- 4. Russian Gap Subdivision 2023 Addition; KPB File 2022-185
Johnson Surveying / Tarcy, Coulliette, Byrd
Location: Russian Gap Road
Cooper Landing Area / Cooper Landing APC**

RUSSIAN GAP SUBDIVISION 2023 ADDITION PRELIMINARY PLAT

ITEM 4 – RUSSIAN GAP SUBDIVISION 2023 ADDITION

STAFF REPORT

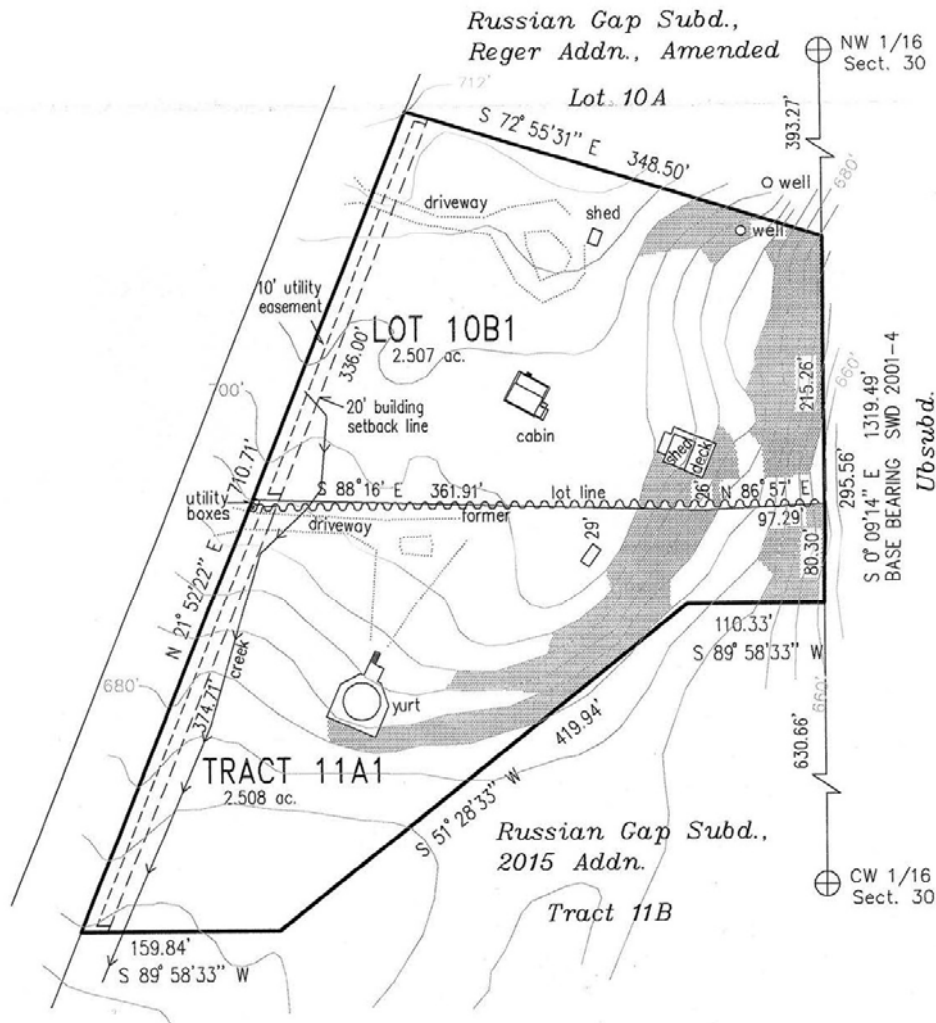
Site Investigation: Steep areas are present and shown. They are mostly within the eastern portion of the subdivision. **Staff recommends the steep terrain be removed and plat note 5 remove the portion regarding contours.**

There are low wet areas present along the western boundary. They are designated as kettle. The wetlands are not depicted but the surveyor has noted a creek is present and plat note 5 indicates it is the extent of the wet area. KPB GIS data does not indicate a creek within that area and parent plats did not indicate the creek. This may be the result of development. **Staff recommends the creek and the plat note remain on the final plat and a wetlands determination note be added to the plat.**

Utility Easements Russian Gap Subdivision, SW 2001-4, granted a 20 foot utility easement adjacent to the Russian Gap Road dedication. The easement was carried over onto the replats. **Staff recommends the depiction, labeling, and notes be revised to carry over the 20 foot utility easement.**

Add legend to drawing

- Staff recommendation:** *Update Tract 10B to "Lot". Remove "Amended" from the parent subdivision name.*
- C. The location, width, and name of existing or platted streets and public ways, railroad rights-of-way, and other important features such as section lines or political subdivisions or municipal corporation boundaries abutting the subdivision;
Staff recommendation: *Label Russian Gap Road and provide a right-of-way width label.*

- D. A vicinity map, drawn to scale showing location of proposed subdivision, north arrow if different from plat orientation, township and range, section lines, roads, political boundaries, and prominent natural and manmade features, such as shorelines or streams;
Staff recommendation: *Include the boundary and a label for Chugach National Forest. Center the section numbers.*

- G. The status of adjacent lands within 100 feet of the proposed subdivision boundary or the land status across from any dedicated rights-of-way that adjoin the propose subdivision boundary, including names of subdivisions, lot lines, block numbers, lot numbers, rights-of-way; or an indication that the adjacent land is not subdivided;
Staff recommendation: *Remove "Amended" from the subdivision label to the north. Provide the depiction of Russian Gap Road and lots west of the right-of-way.*

- H. Approximate locations of low wet areas, areas subject to inundation, areas subject to flooding or storm water overflow, and the line of ordinary high water. This information may be provided on an additional sheet if showing these areas causes the preliminary plat to appear cluttered and/or difficult to read;
Staff recommendation: *There are some areas of kettle. Not shown but a creek is depicted.*

Staff recommendation: *Per code all setbacks shall be depicted. Per the code for RR LOZD, the property is subject to the following setbacks, 60 foot front, 25 side lot lines, and 40 rear. Provide depiction and labels and provide a reference to the plat note for setbacks.*

- Plat note 1 - Remove to provide new notes stated above.
- Plat note 3 – “These lots are within Russian Gap Subdivision Local Option Zoning District with notice recorded with the Seward Recording District in Book 110 Page 725, amendments within Serial Number 2011-000638, 2011-000909-0, and 2020-001405-0.”
- Plat note 4 – add “...and Book 111 Page 105.”

Plat note 5 – remove “Contour interval 4’.” Leave the remainder of the note on the final.

Staff recommendation: Make sure the signature lines indicate the former lot the owner is signing. Comply with 20.60.190.
